MIL-C-19803F
AMENDMENT 6
02 April 2001
SUPERSEDING
AMENDMENT 5
29 September 1995

MILITARY SPECIFICATION

CONVERTER, LIQUID OXYGEN, 10 LITER, GCU-24A/A

FIGURE 3. Front view.

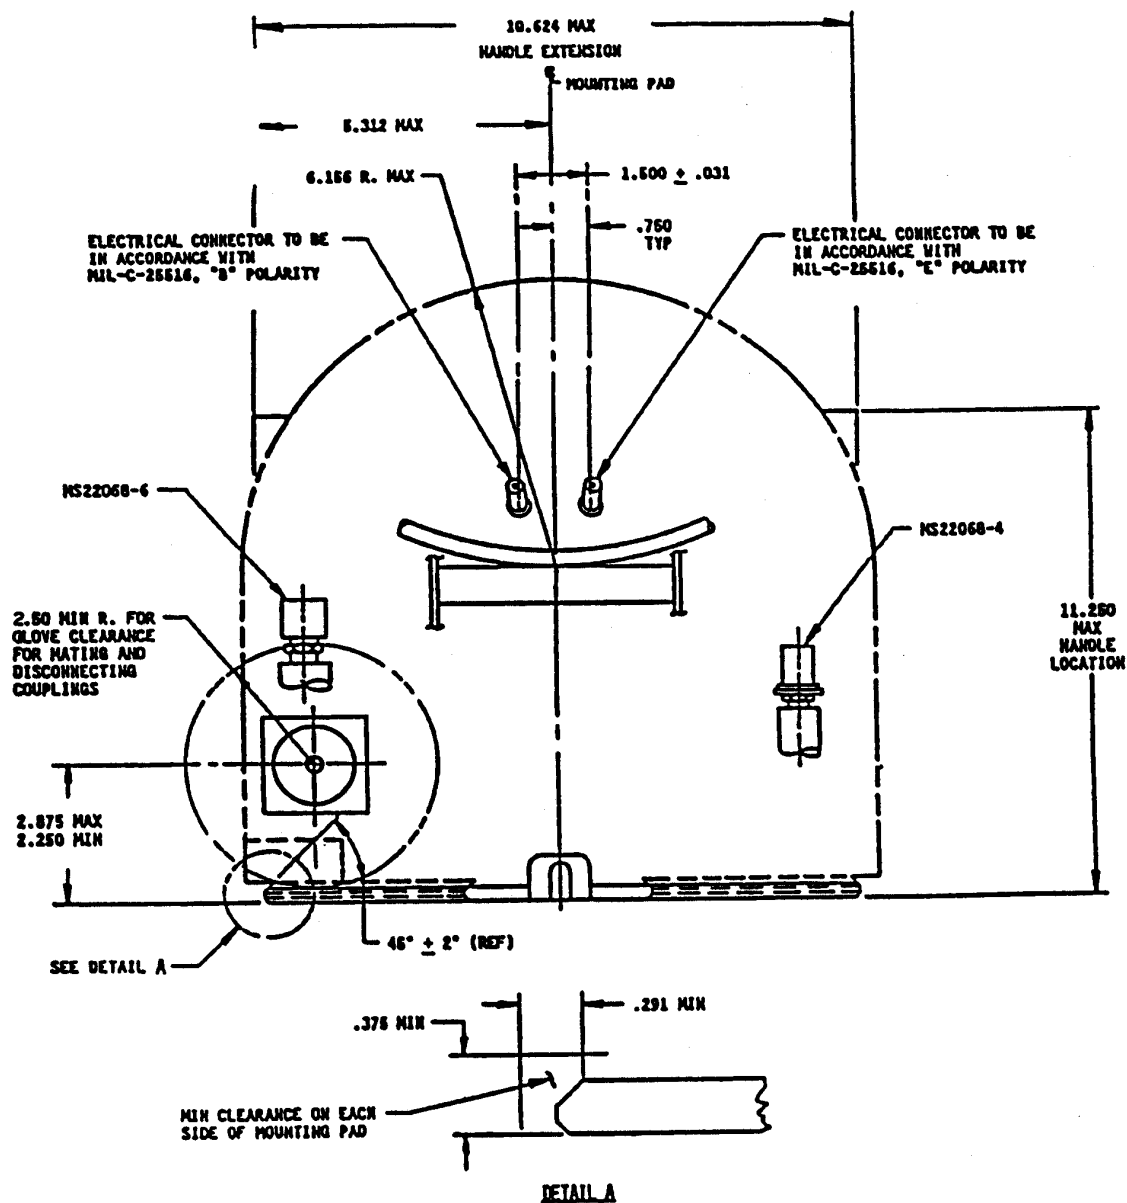
Figure 3: Delete and substitute new figure 3.

FIGURE 4. Mounting base.

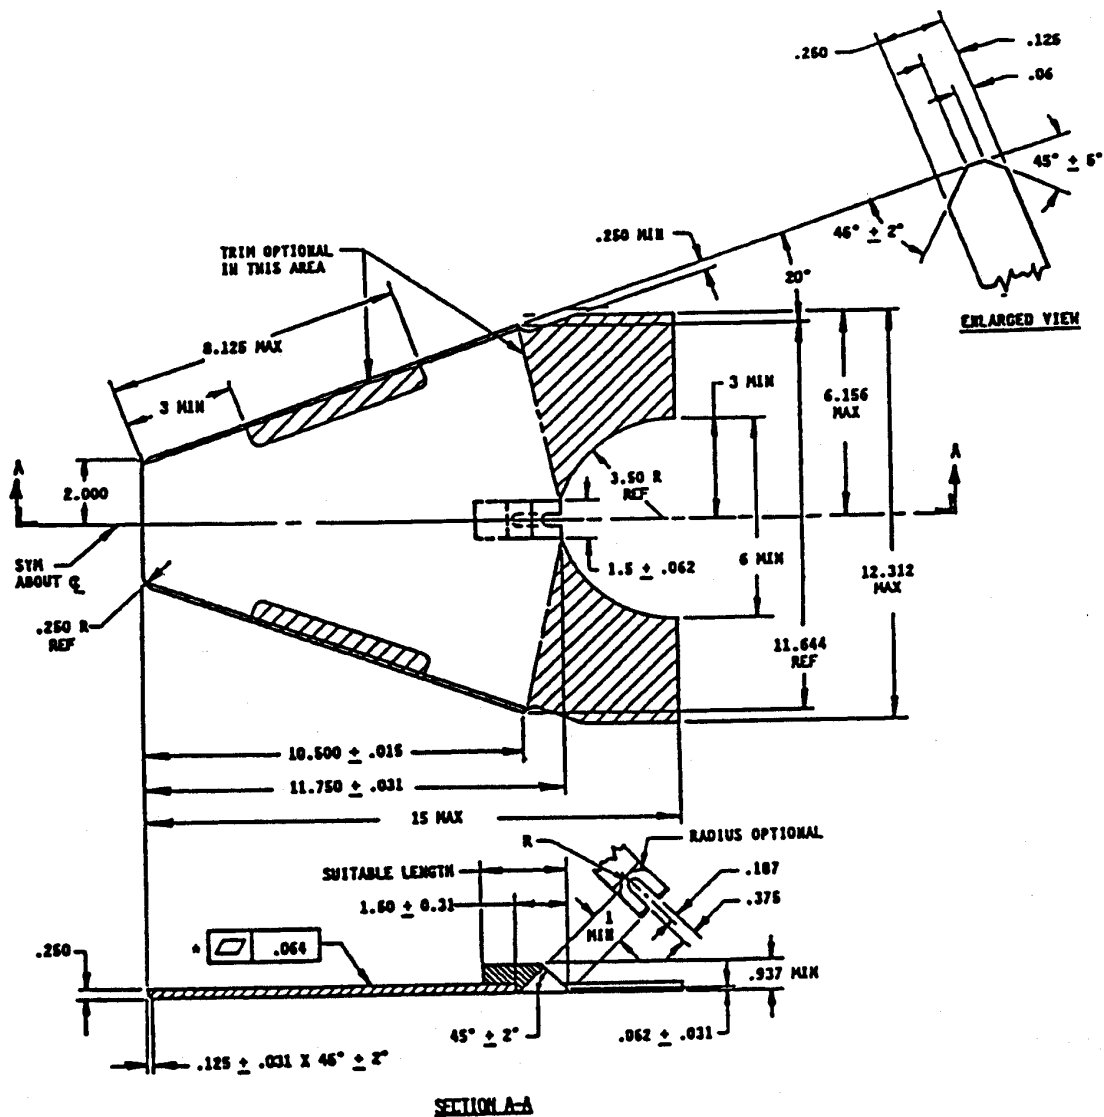
“3.6.13 Mounting base. The mounting base shall conform to the configurations and dimensional requirements of figure 4.”

Figure 4: Delete and substitute new figure 4.
